# A428 Black Cat to Caxton Gibbet improvements

9.46 Applicant's Comments on Deadline 3 Submissions

**9.46 Applicant's Comments on Deadline 3 Submissions**

<b>Regulation Reference:</b>	Rule 8 (1)(k)
<b>Planning Inspectorate Scheme Reference</b>	TR010044
<b>Application Document Reference</b>	TR010044/EXAM/9.46
<b>Author</b>	A428 Black Cat to Caxton Gibbet improvements Project Team, National Highways

Figure 6-1 –Junction Models - Cambridgeshire

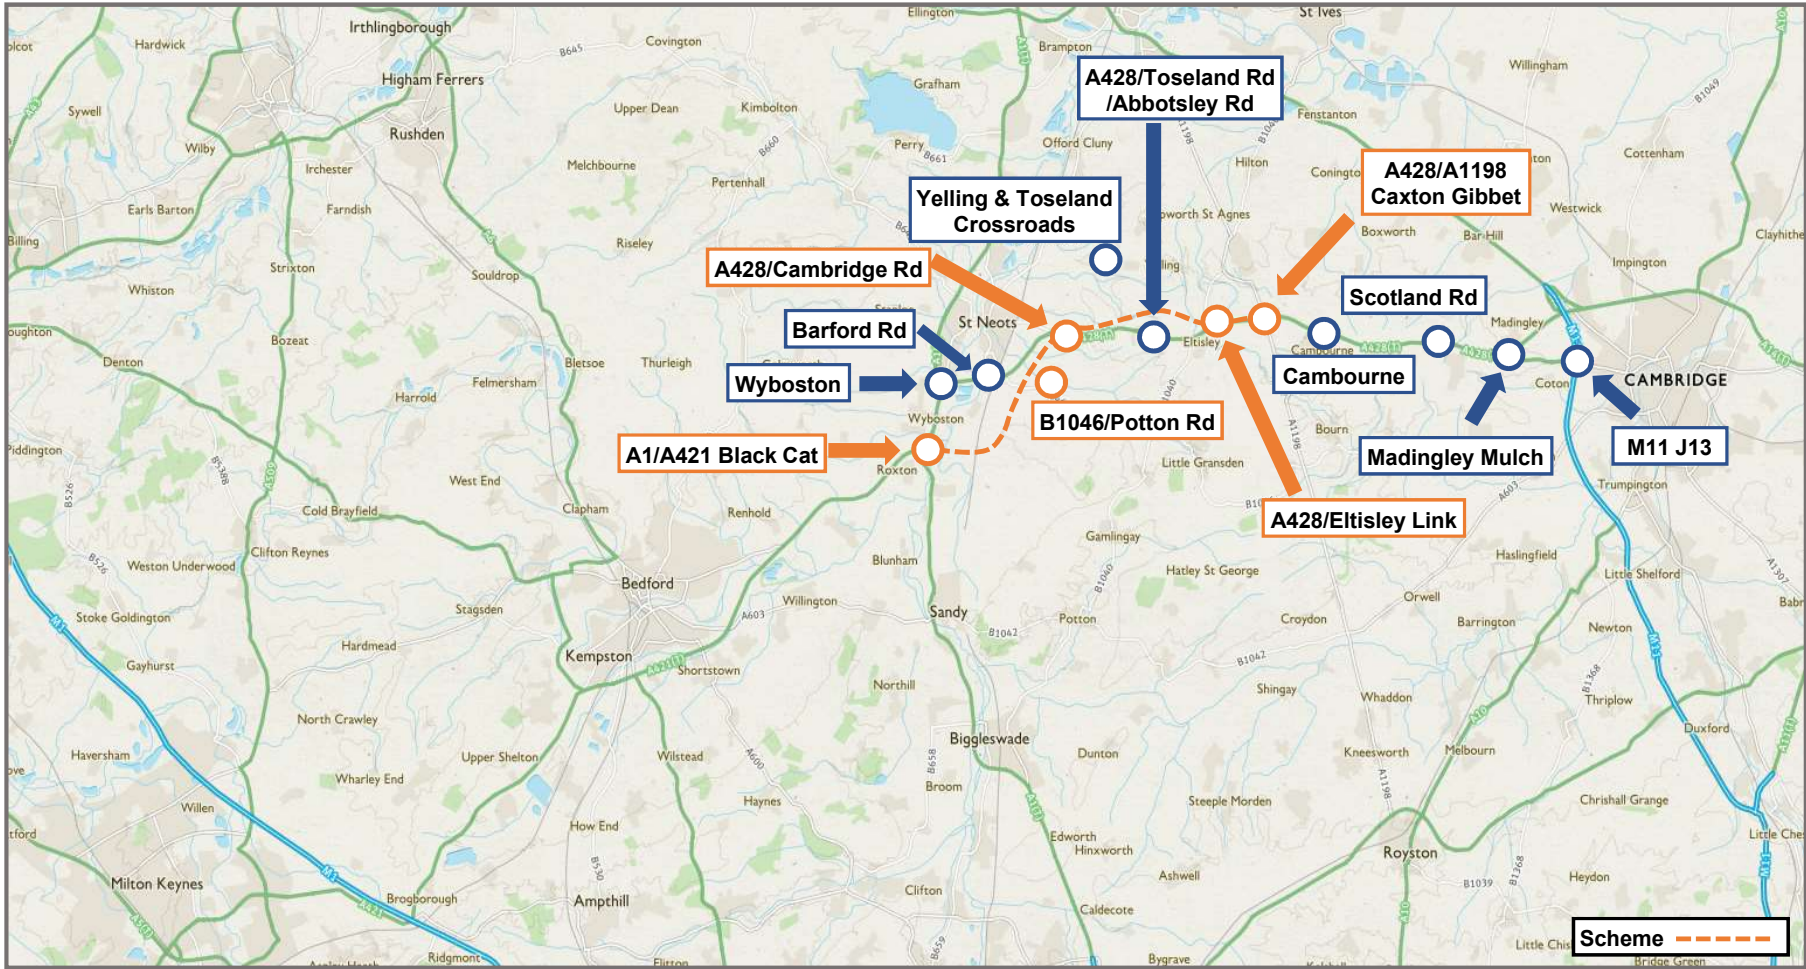
Reference Number	Interested Parties Submission/Applicant's Comments
<b>9.10 Junction Technical Modelling Note</b>	
REP3-038a	<p><b>Junction Locations - Figure 6.1</b></p> <p>Not all of the junctions listed in the text are shown on figure 6.1.</p>
Applicant's Comments	The Applicant acknowledges this point and a correct map is attached to this response, at Appendix A.
REP3-038b	<p><b>Scheme Junctions 6.3.8</b></p> <p>The Applicant states that “a comparison has been undertaken and which shows that the SATURN base flows (including HGV flows) are significantly aligned with the surveyed flows”</p> <p>Not all of this analysis has been provided to CCC. CCC wishes to discuss the detail of this comparison exercise with the Applicant.</p> <p>CCC understands that this only compares modelled &amp; NH's observed flows at B1046/Potton Rd and one of the 2 Eltisley jns B1040 St Ives Rd/A428 CCC analysis of these 2 counts concludes that the counts are not sufficiently aligned with the modelled flows to justify the Applicant's approach.</p> <p>Furthermore, CCC analysis of modelled vs observed counts at the remaining junctions, Black Cat, Caxton Gibbet and Cambridge Rd arrives at the same conclusion.</p> <p>The key differences are in turning movements at the junctions, although some link flows are not sufficiently aligned either. See the example provided in the LIR [REP2-003].</p>

Reference Number	Interested Parties Submission/Applicant's Comments
Applicant's Comments	<p>A response in relation to Wyboston, Barford Road and Madingley Mulch junctions is contained in the Scope of Junction Model Sensitivity Test [REP3-029], submitted at Deadline 3.</p> <p>Further details are provided in respect of each of these junctions individually in the responses to points REP1-038s to REP1-038u below.</p>
REP1-038d	<p><b>Existing junctions with no calibrated/ validated base models 6.4.5a</b></p> <p><i>"The initial modelling analysis indicated that the Scheme would result in either a significant capacity improvement at junctions with existing capacity issues"</i></p> <p>If turning movements in the base SATURN model do not match observed counts at individual junctions then the initial modelling analysis using SATURN turning flows is flawed in terms of assessing junction capacity. The modelling is important as it informs the design of the junctions and gives the Councils confidence that the design is appropriate for future traffic flows on the Councils road network.</p>
